Watermaster Review Form:

Water Right Transfer

Transfer Application: T-14315

Transfer Application Map Permit S-31523, Certificate 41138 Malheur County, OR

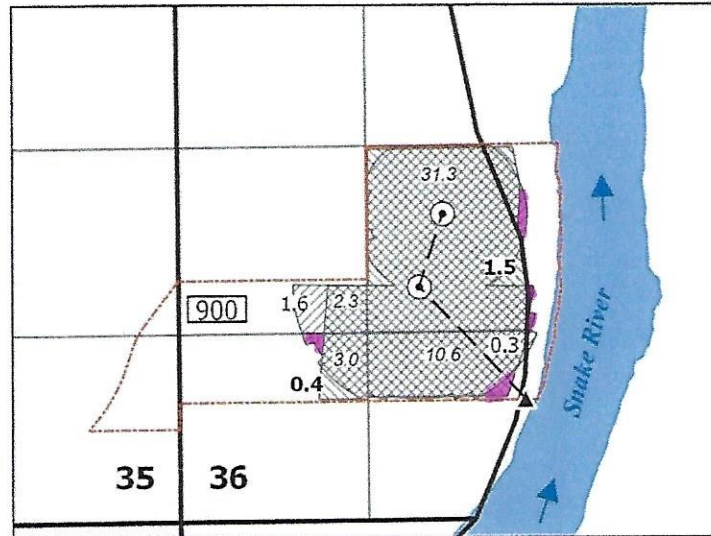
- There are "FROM" acres identified in (SE, SW) on transfer map (hatching), but no acres mentioned in table or map.
 - There are "TO" acres identified in (NE, SW), (SW, SW) on transfer map (hatching), but no acres mentioned in table or map.
 See attached transfer map with highlighted areas of concern.

Areas of Concern

Review transfer map and table 2 and amend to clarify "to" and "from" acreages for each quarter, quarter to avoid enlargement of the water right.
